ADDENDUM NO. 2

Project: USCA Pedestrian Bridge
Project Number: H29-9545-PG

Attachment: Lateral Bracing Details

Lateral Bracing Detail
 USCA Pedestrian Bridge
 State Project No. H29-9545-PG
 University of South Carolina
 Aiken County, SC

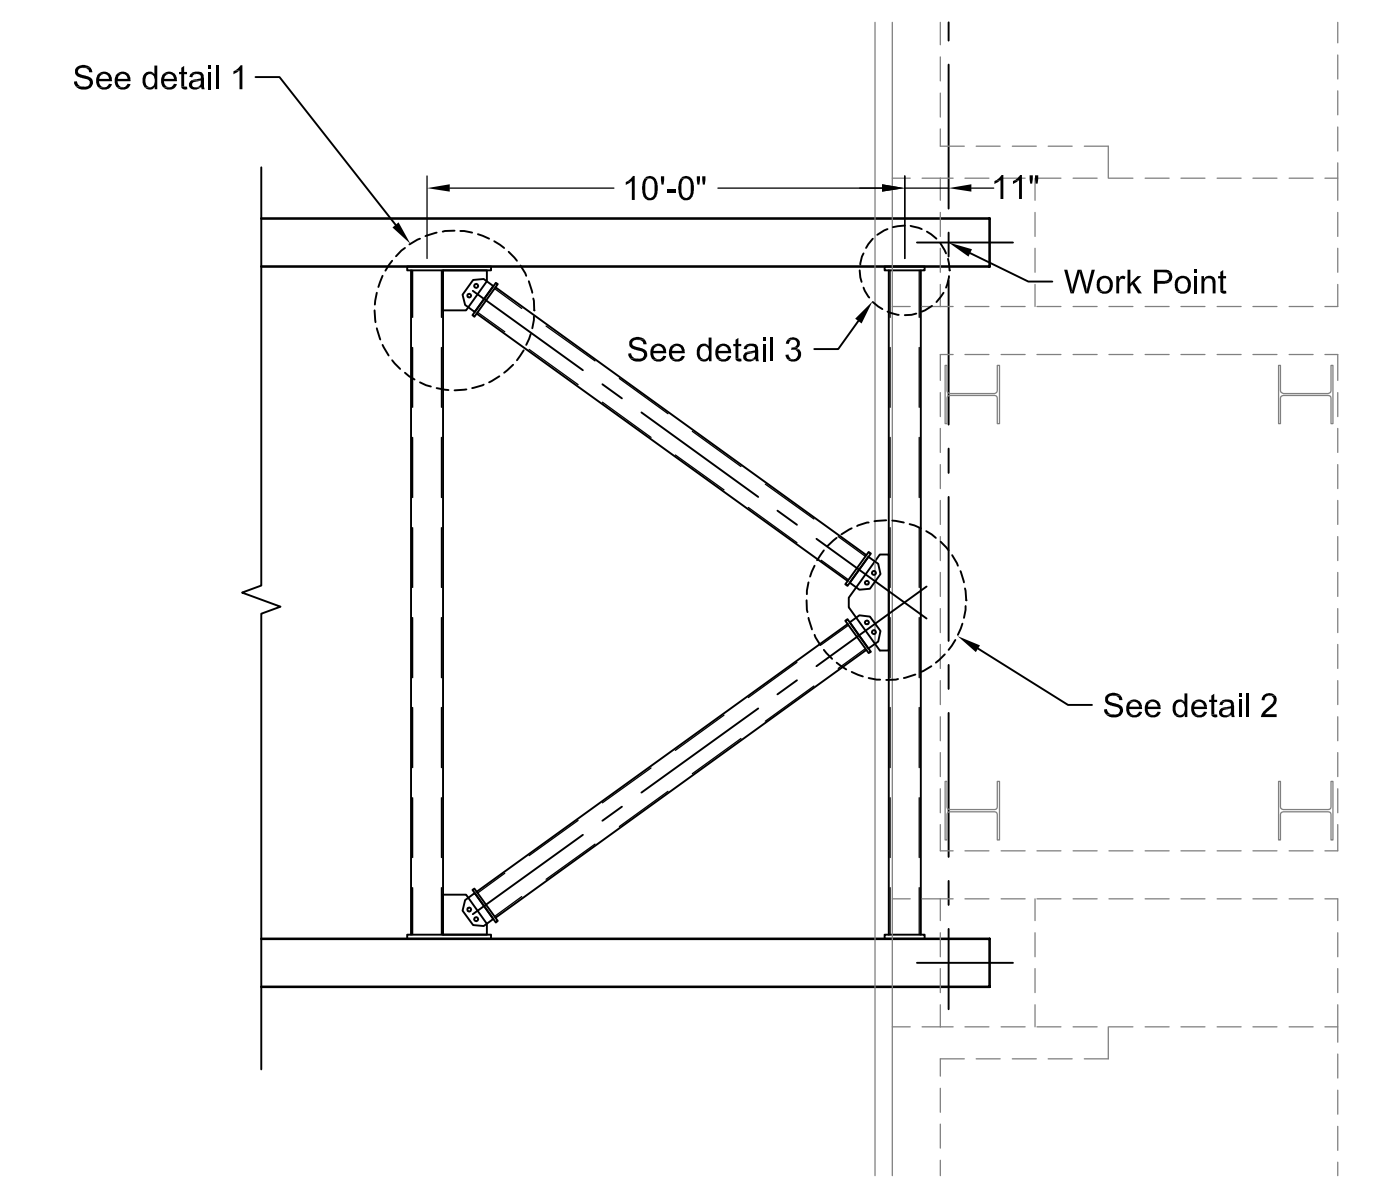
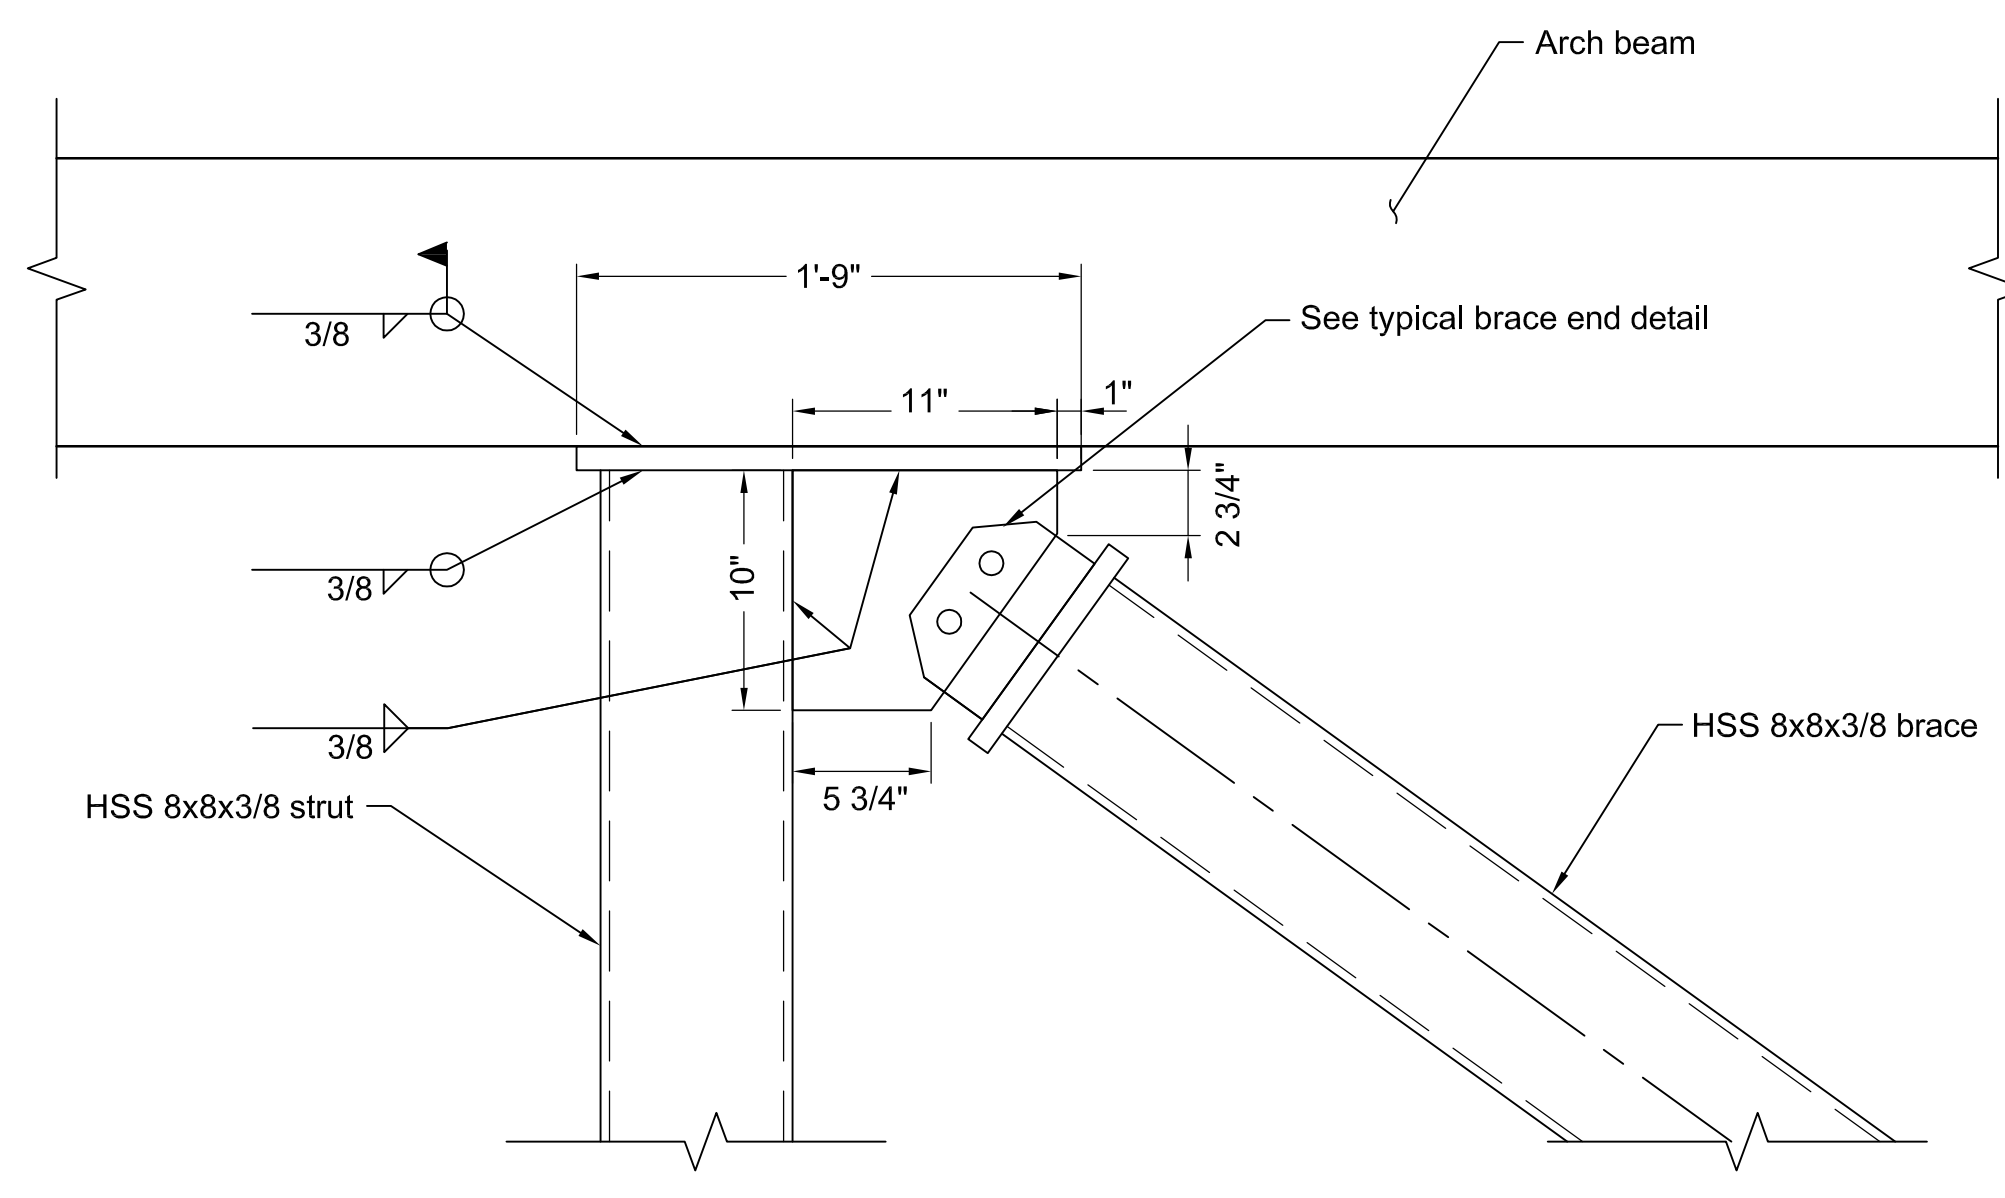
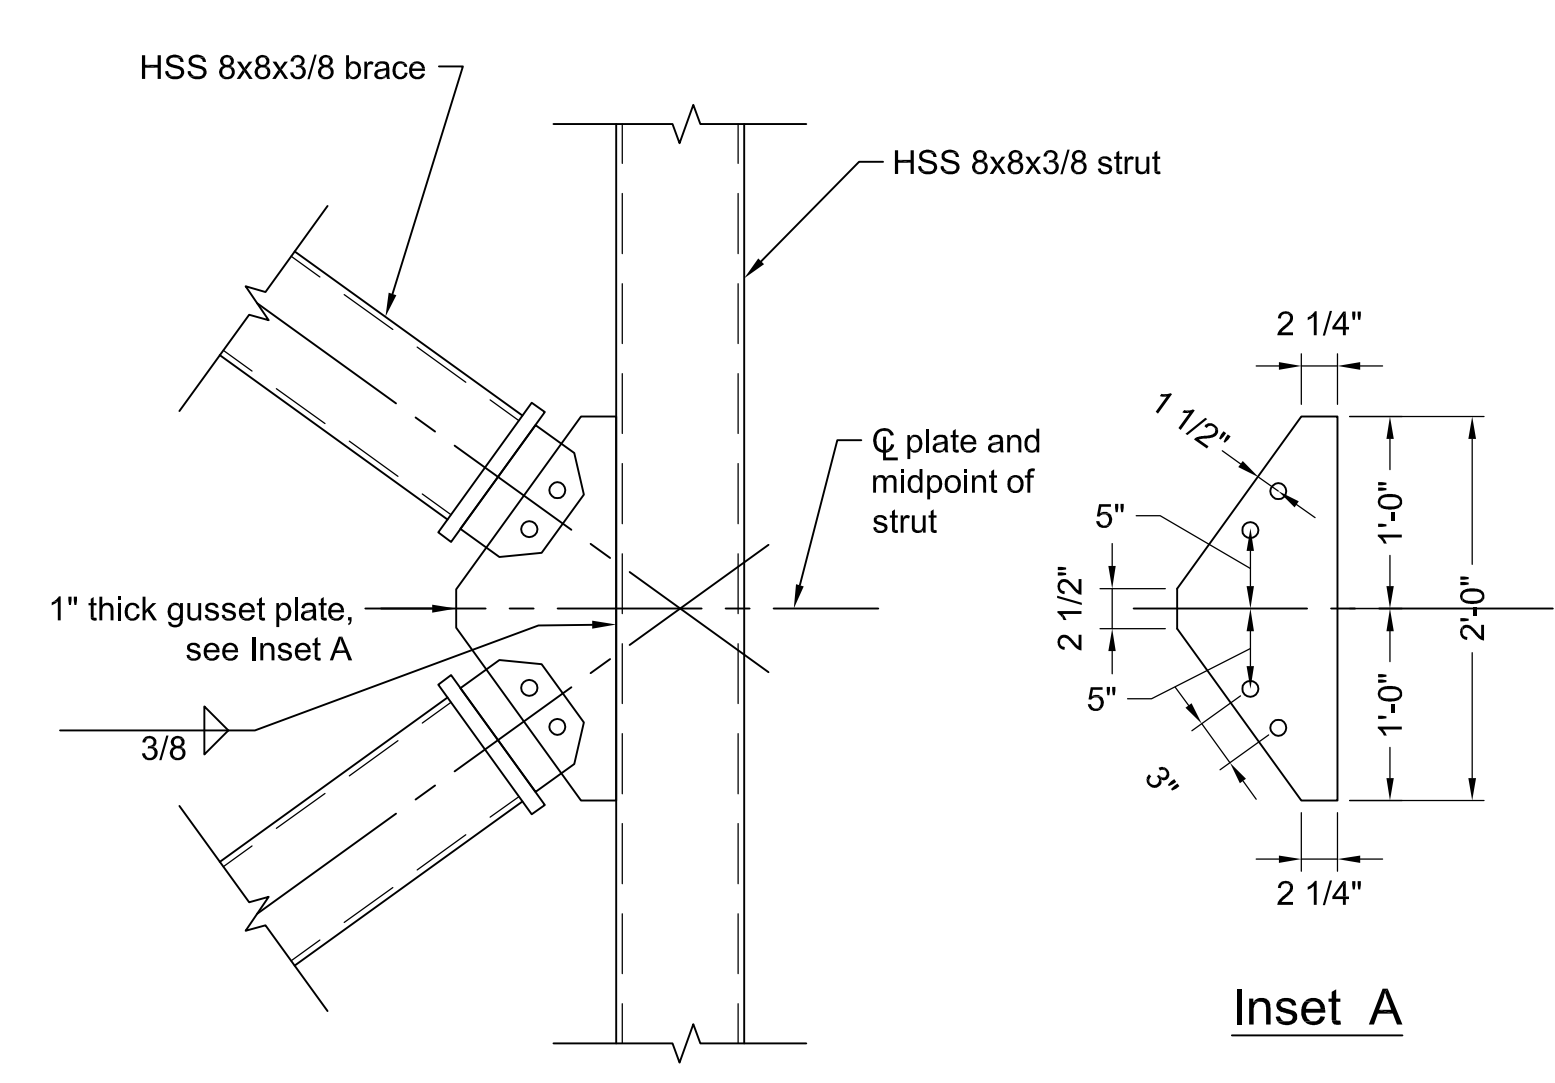
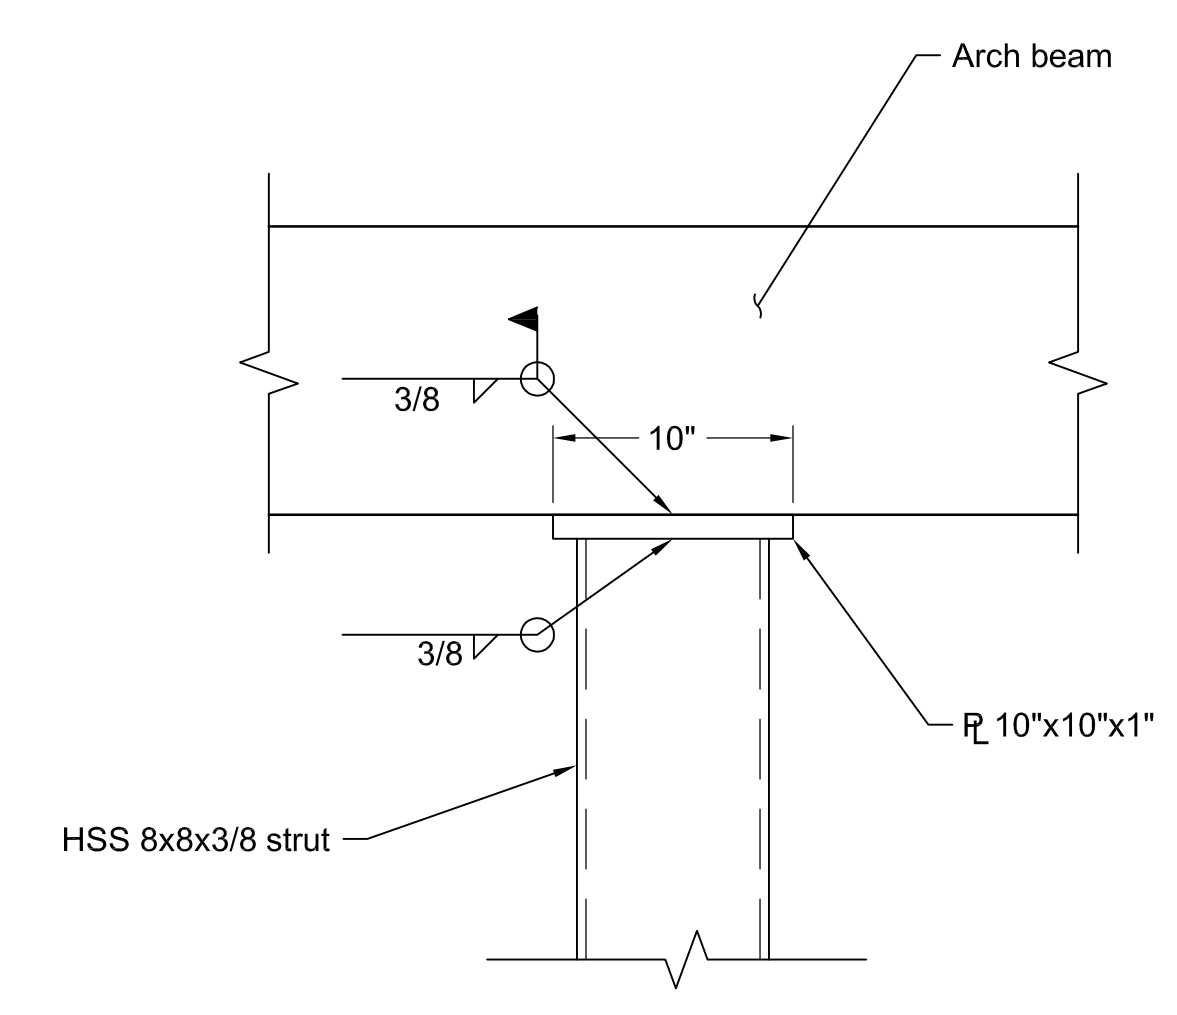
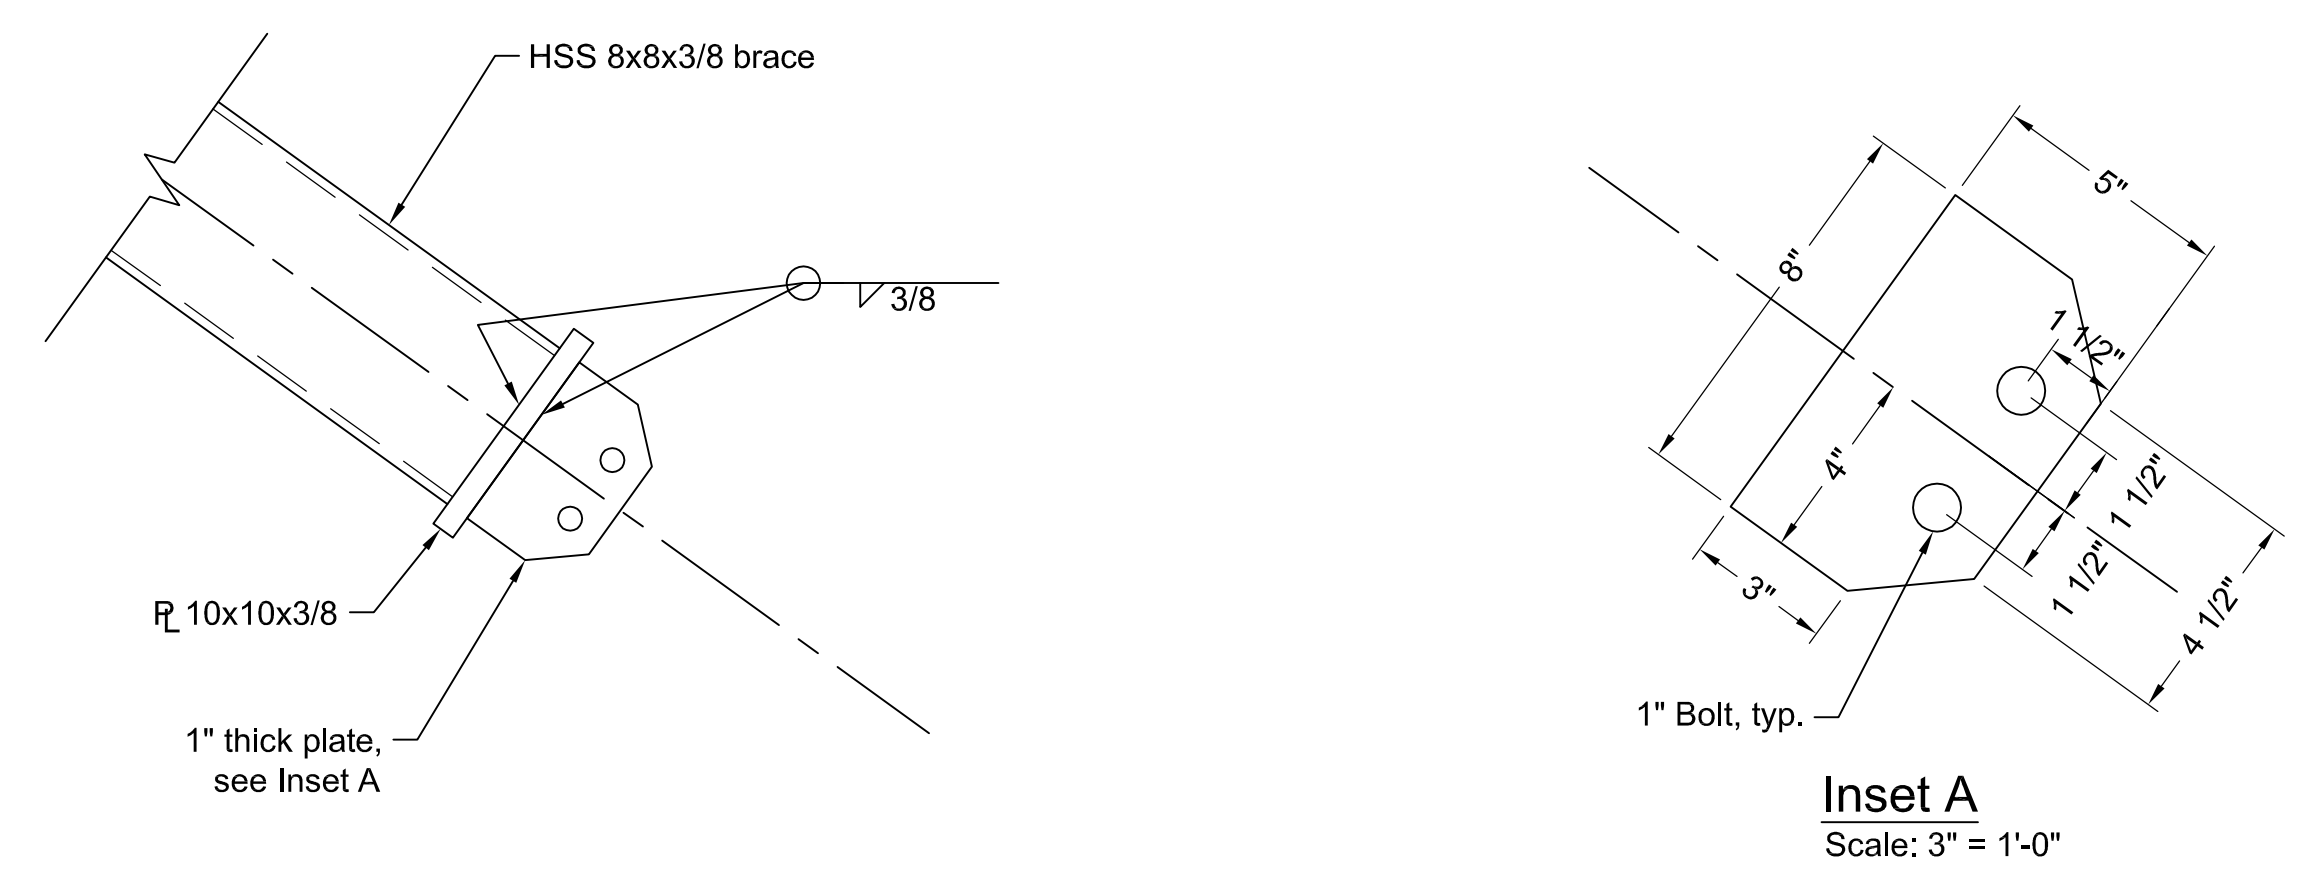
See attached lateral bracing details to be added to the contract drawings via this addendum.
